Planning Commission Staff Report

SUBJECT: FM20-02 PB BELL GILBERT COMMONS SEPARATION FENCE: REQUEST TO APPROVE MODIFICATIONS TO SEPARATION FENCE REQUIREMENTS ON APPROXIMATELY 8.63 ACRES, GENERALLY LOCATED AT THE SOUTHWEST CORNER OF COOPER AND BASELINE ROADS, AND ZONED MULTI-FAMILY/MEDIUM (MF/M) WITHIN THE SHOPPES AT GILBERT COMMONS PLANNED AREA DEVELOPMENT (PAD) OVERLAY.

**FINDINGS OF FACT
FM20-02, PB Bell Gilbert Commons Separation Fence**

Attachment 4 - Exhibits

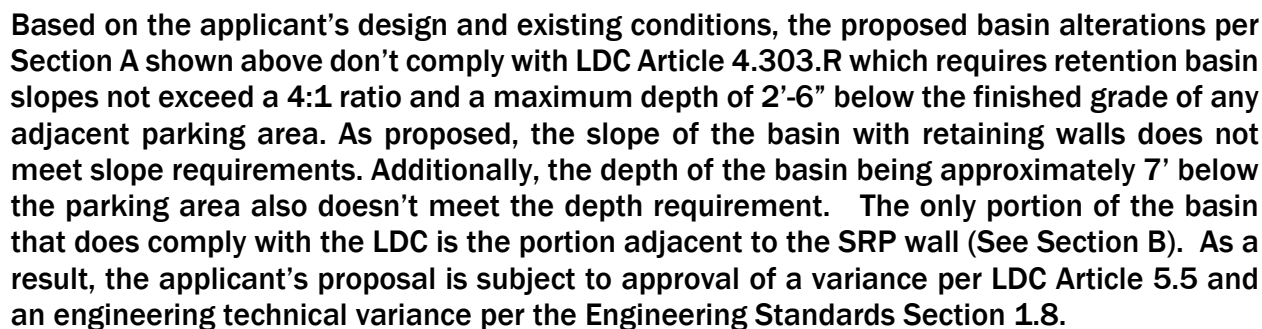
The existing retention basin was constructed in 2003 as regional drainage for 9 lots within the Shoppes at Gilbert Commons and a portion of the Fuller Industrial Park and is encumbered by a drainage easement that was recorded on the Final Plat. With the new apartment complex development, the applicant is proposing to construct parking spacing along most of the western boundary which will alter approximately 7-10% of the exiting easement/retention basin and include grading, filling and the removal of existing landscaping. To accommodate the new parking spaces, retaining walls and a separation fence varying in height from 3'-6" in front of the SRP substation to 6'-1" along the widest portions of the basin and no fencing along the northern portion in the middle of the basin are proposed. It must be noted that the existing conditions of the basin including the

All storm water retention displaced by the additional fill dirt will be relocated to five (5) new underground retention tanks in the northwest corner of the site. All retention capacity is being evaluated as part of the concurrent Design Review application.

WALL LAYOUT AT WESTERN PROPERTY LINE

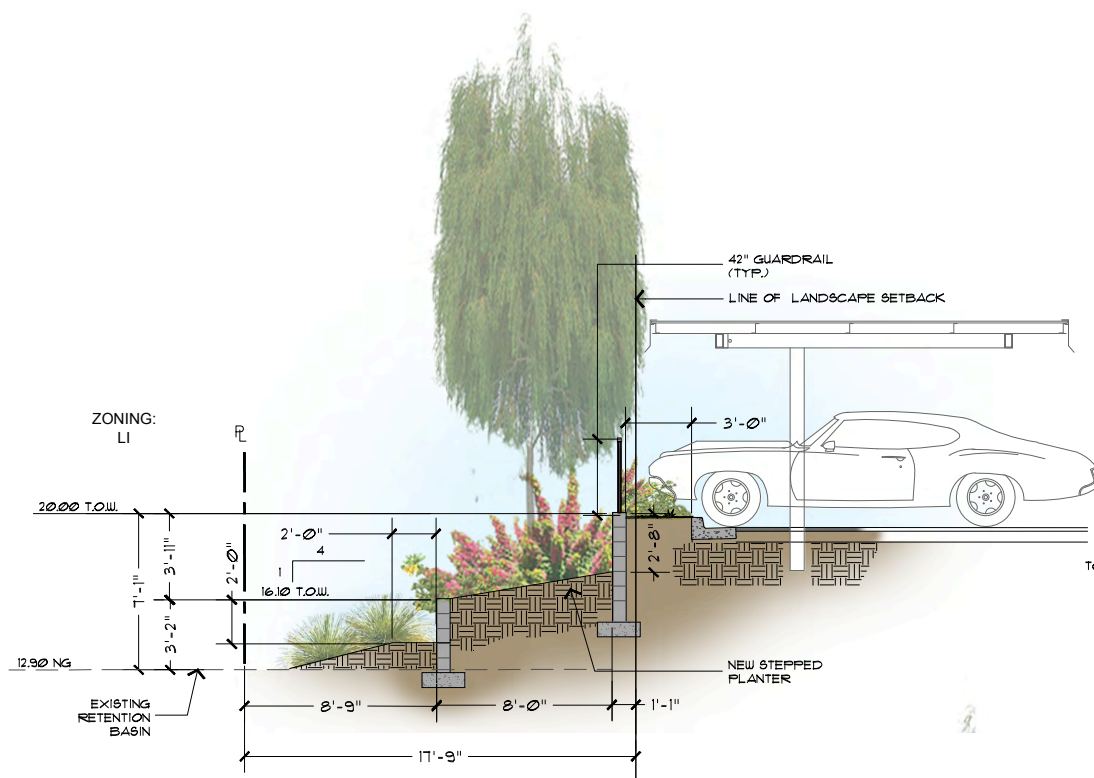
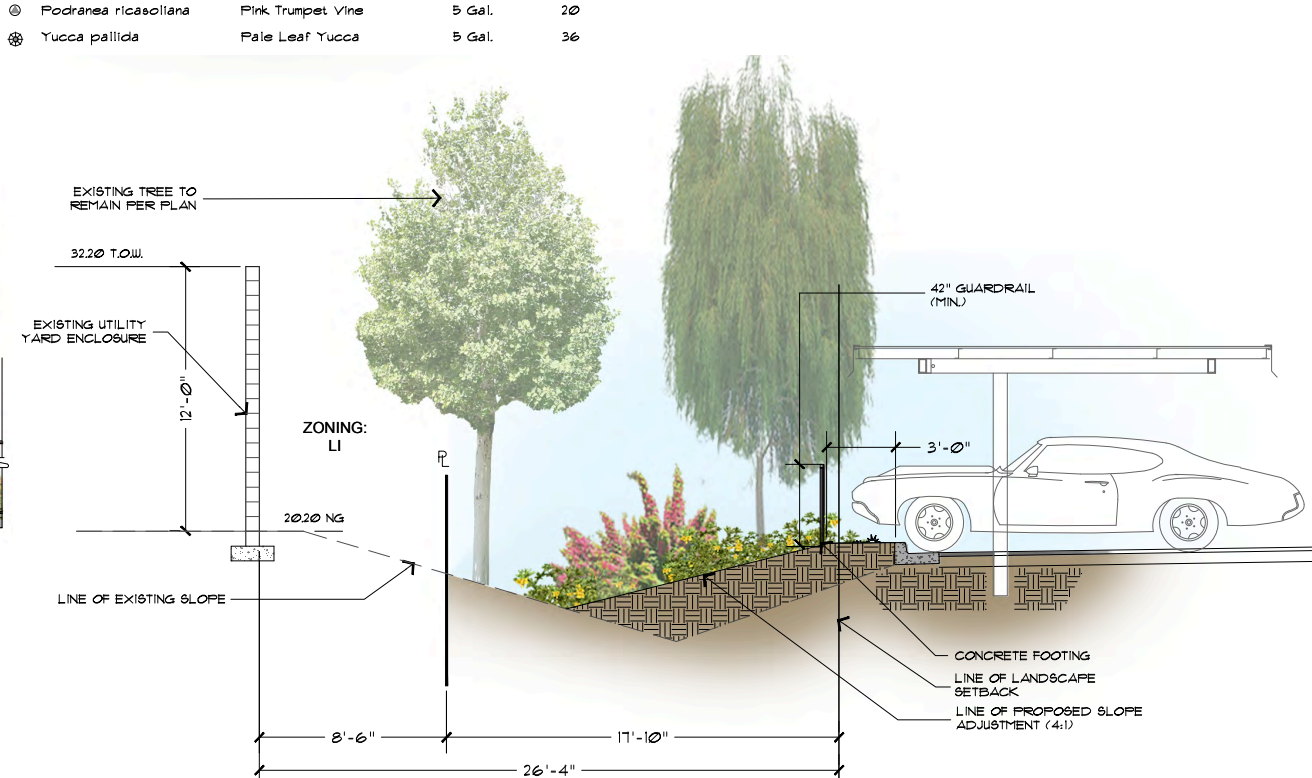
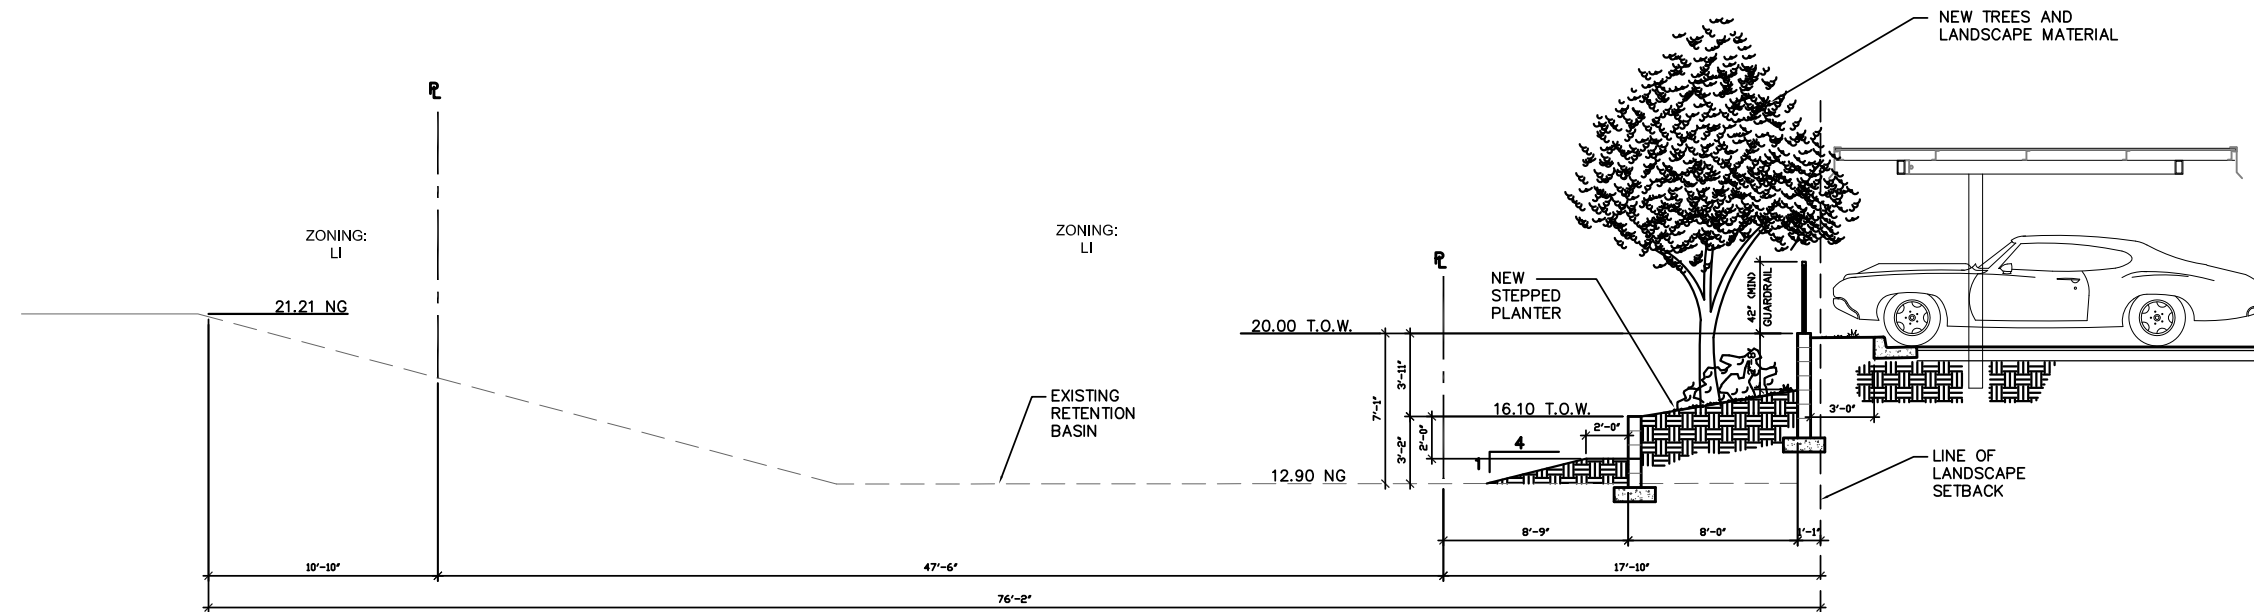
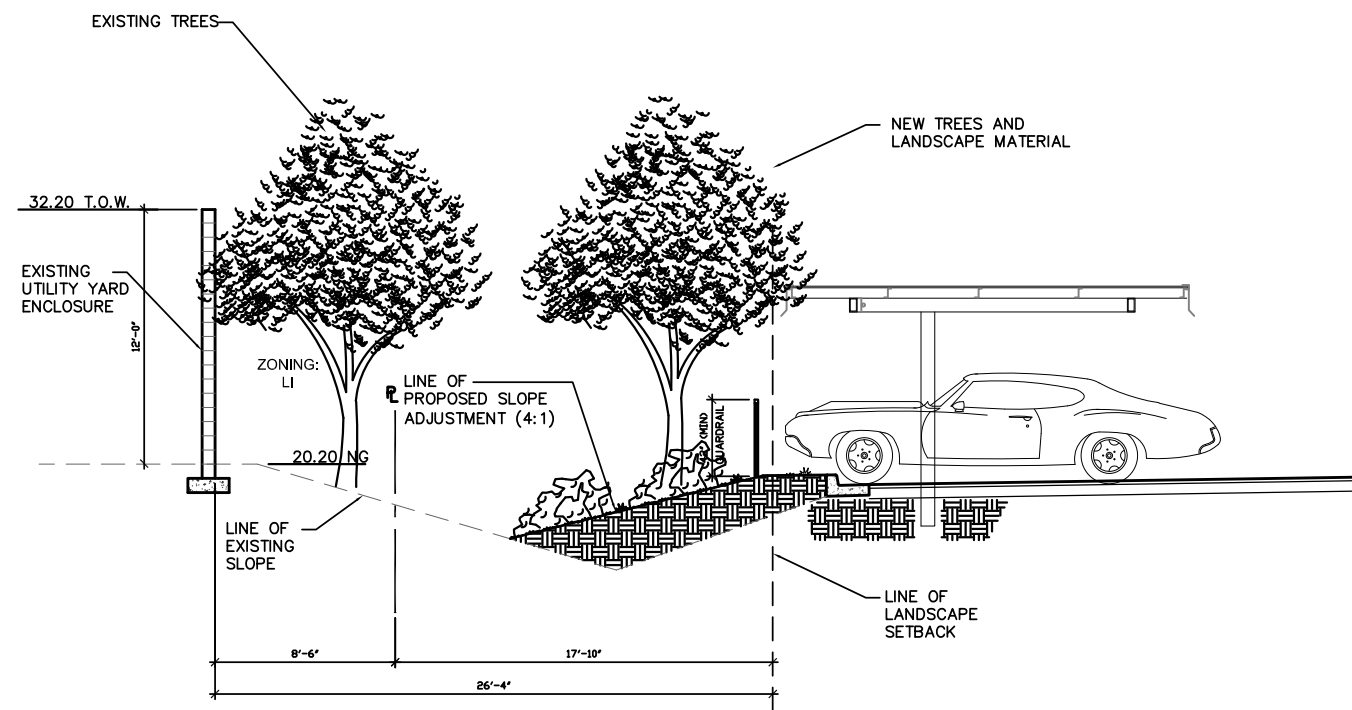
1. Allow a separation wall to be constructed within the required 17'-10" perimeter landscape area along portions of the western property boundary.
2. Allow a 6'-1" tall wall where 8' tall is required adjacent to a non-residential district or use.
3. Allow for the top 3'-6" of the proposed wall to be view fencing.
4. Allow a 3'-6" tall view fence instead of an 8' solid wall for approximately 260' along a portion of the southern half of the western boundary in-front of the existing SRP substation which has an existing 10' tall solid wall.
5. Allow for no fencing for approx. 265' along a portion of the northern half of the western boundary in the middle of an existing retention basin.

The proposed alterations to the existing basin don't comply with LDC Article 4.303.R and require the approval of a variance per LDC Article 5.5 and an Engineering technical variance per the Engineering Standards Section 1.8. Without the approval of both Variances this criterion will not be met, and the site would need to be redesigned to comply.

1. The Project shall be in substantial conformance with the site plan and wall detail shown on the Exhibits provided under Attachment No. 4.
2. The Separation Fence approval is subject to approval of a variance per LDC Article 5.5 and an Engineering technical variance per the Engineering Standards Section 1.8. Should these variances modifying the maximum retention basin depth and slope not be approved, an amendment to this Separation Fence Modification case will be required that shows compliance with the requirements of the Land Development Code and Engineering Standards and any engineering technical variance required by the Engineering Standards Section 1.8.
